**MEMORANDUM**

SUBJECT: CLARIFICATIONS TO MHRB PERMIT 2018-0002 MCCSD WATER TREATMENT PLANT

The Review Board granted this permit to construct a 1,000-square-foot building with wooden windows and doors; install signs and striping for parking; remove aluminum window and air vents on the southeast corner of the press building; and others (See attachment B). In 2019, the architect submitted for Building Plan Check Review revised drawings that differ from MHRB Permit 2018-0002 as follows:

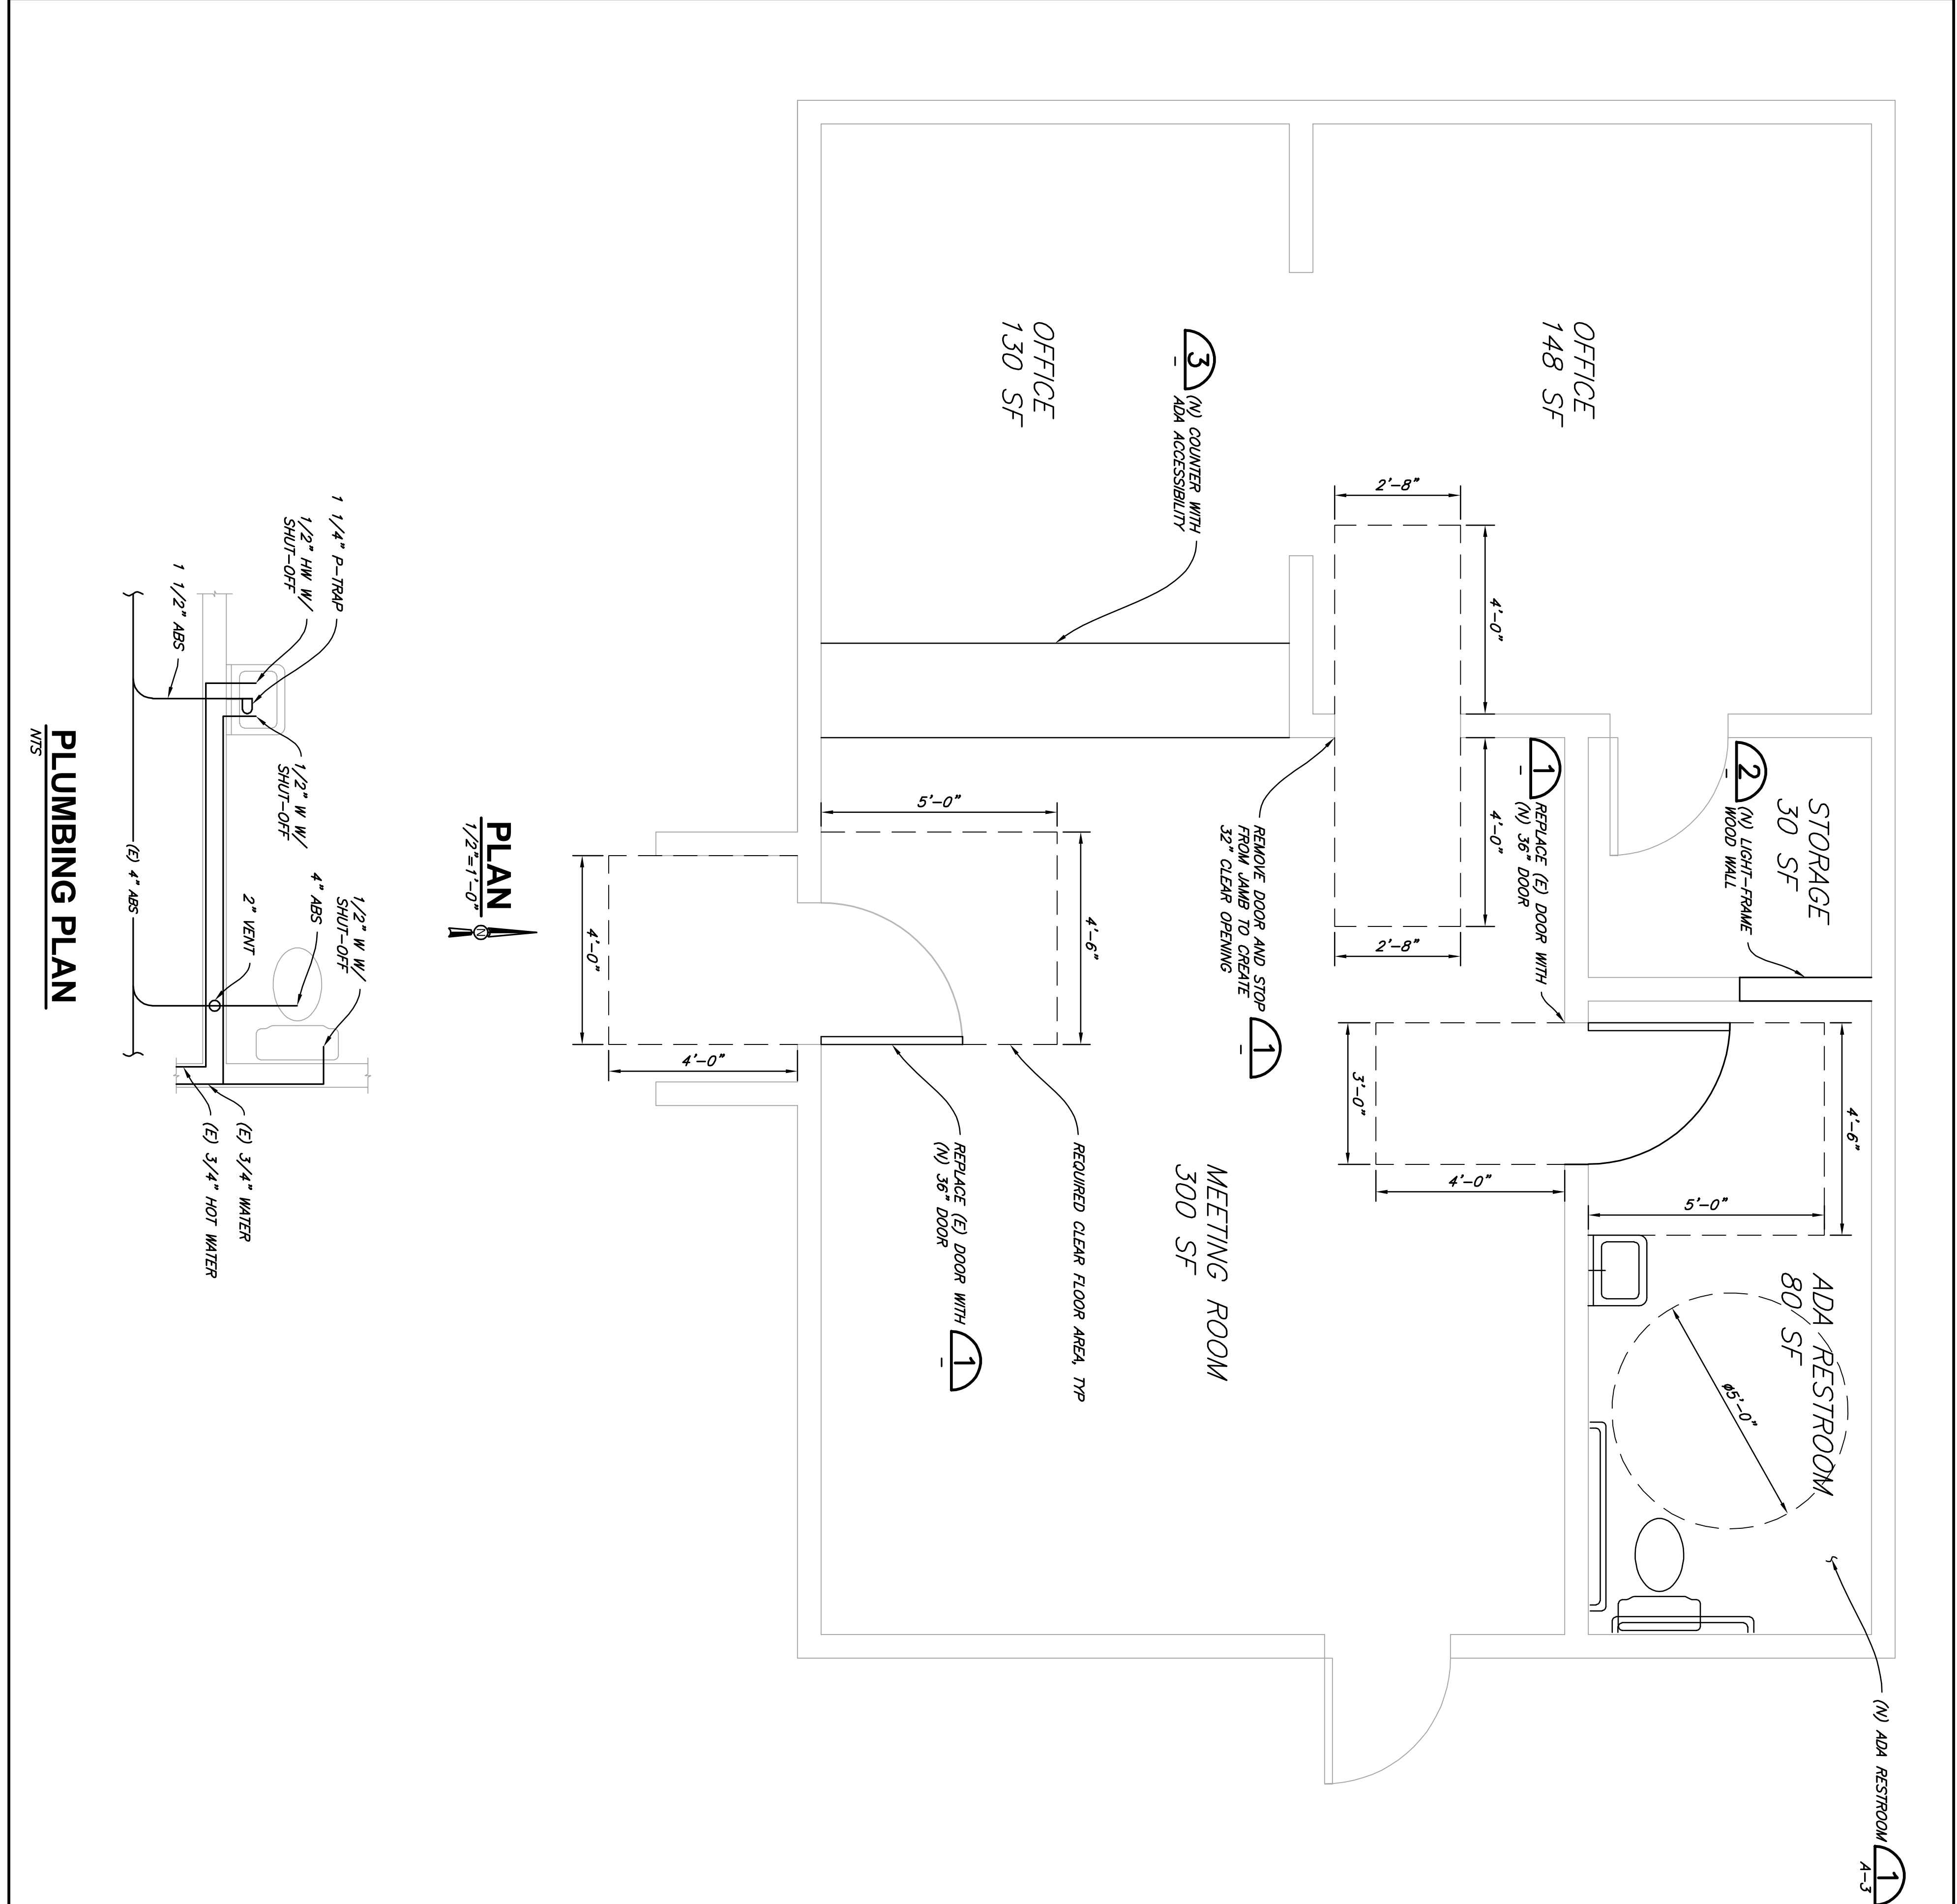
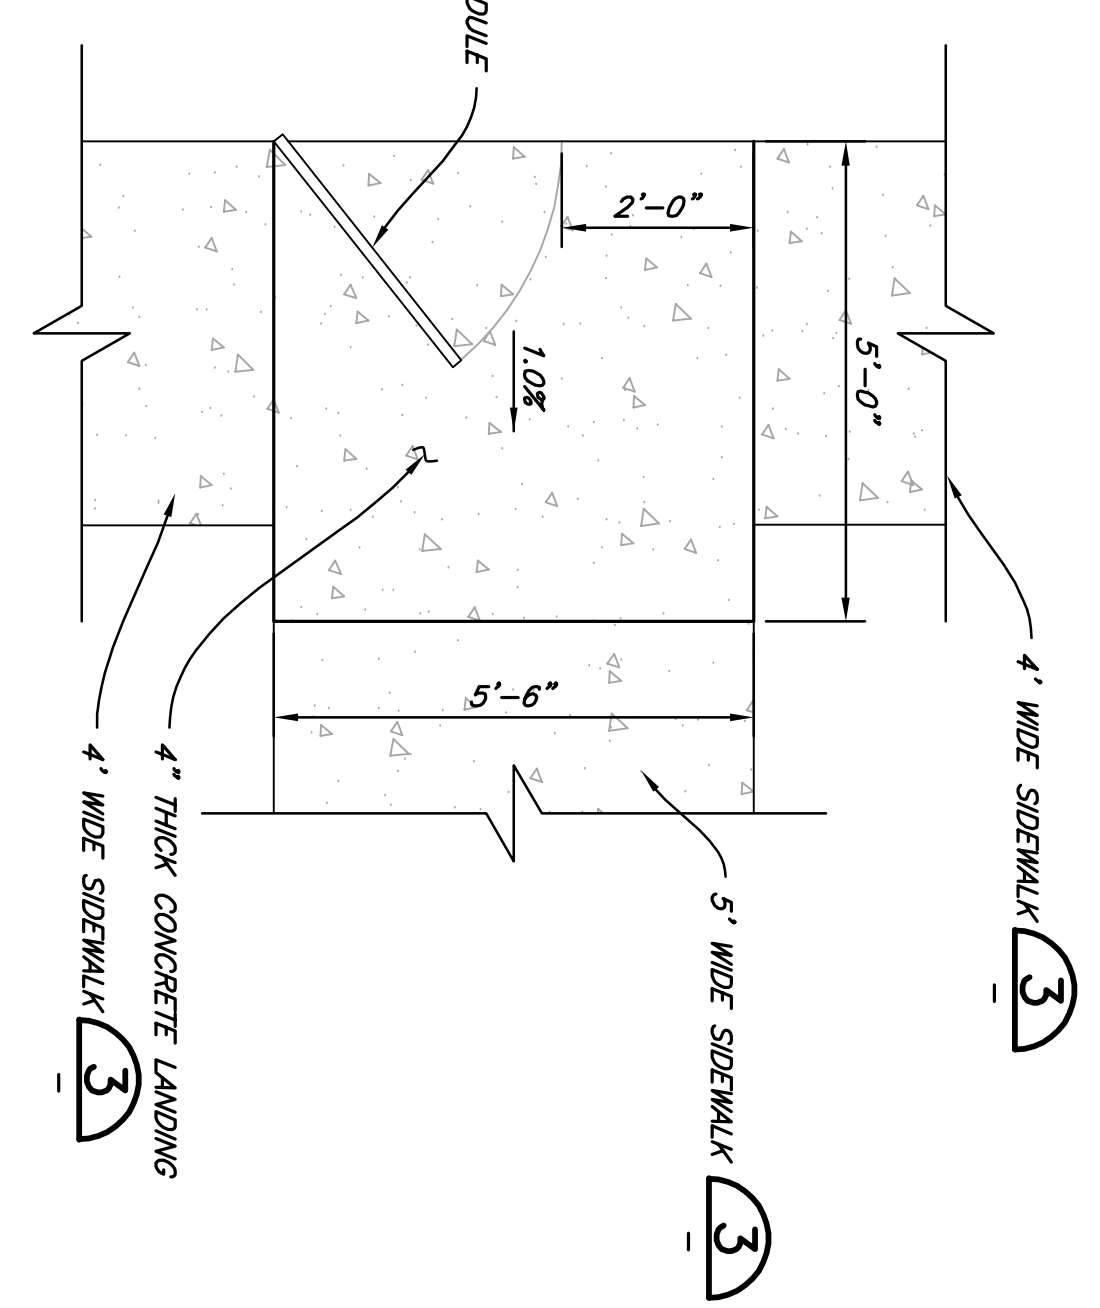
1. The addition of an ADA compliant (cement) surface between the Press Building and the Chlorine Building (See Attachments A and C Sheets C-1.1 and A-4). Visibility of the pathway between the Press Building and the Chlorine Building would be limited to areas within the Water Treatment Plant facility; therefore, Staff recommends that this pathway be considered a part of the previously approved project.

2. A minor change in orientation of the accessible parking-space markings (See Sheets C-1.1 and A-4). Staff recommends that the orientation of the accessible parking-space markings would not have a material effect on the project.

SEQ	DATE	PROJ. NO.
A-4	03/2019	416076.500

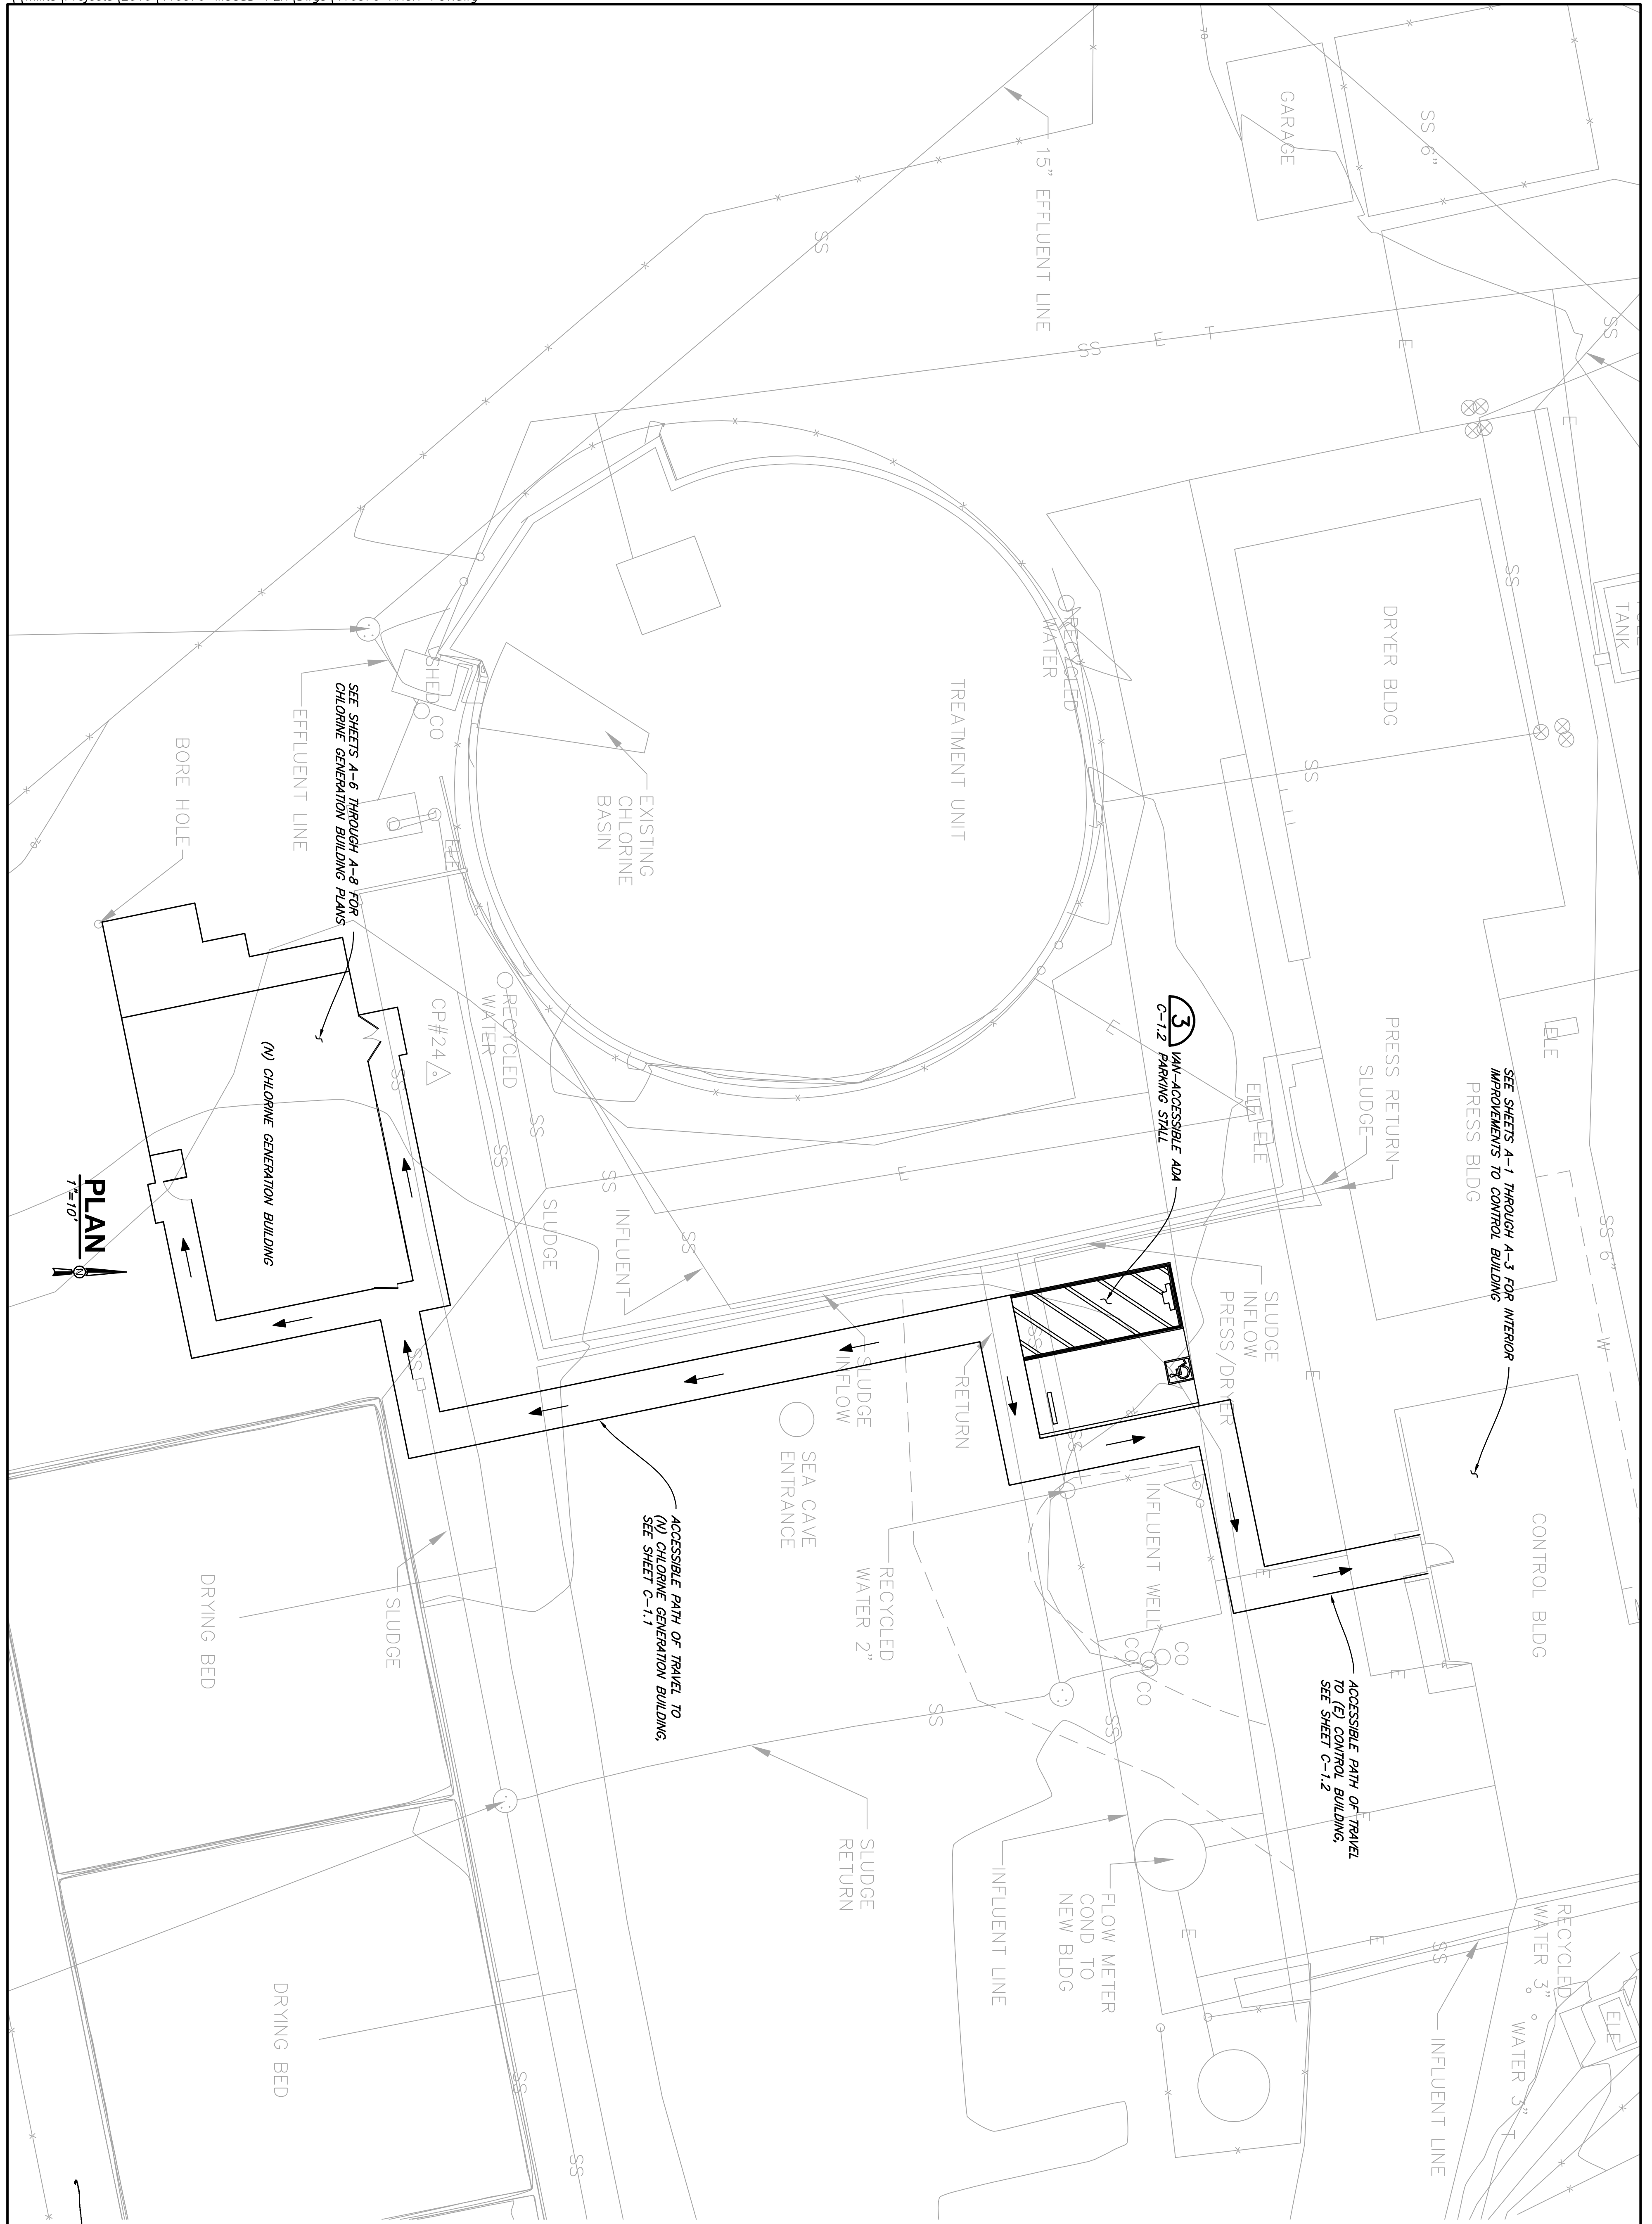
3. Drawings specify fiberglass window frames and doors on the Chlorine Building and the Press Building. Fiberglass differs from the wood window frames and doors specified in MHRB Permit 2018-0002 (See Attachments A and C Sheets A-4 and A-6). Staff recommends that the revised drawings specify exterior wooden doors and wooden window frames, including the proposed replacement door on the Press Building.

**RECOMMENDATION:** Acknowledge MHRB Permit Condition #7 anticipates potential changes to this public works project. Direct Staff to amend MHRB Permit 2018-0002 and to approve drawings specifying wood doors and wood window frames. Alternatively, direct the applicant to apply for a new permit.
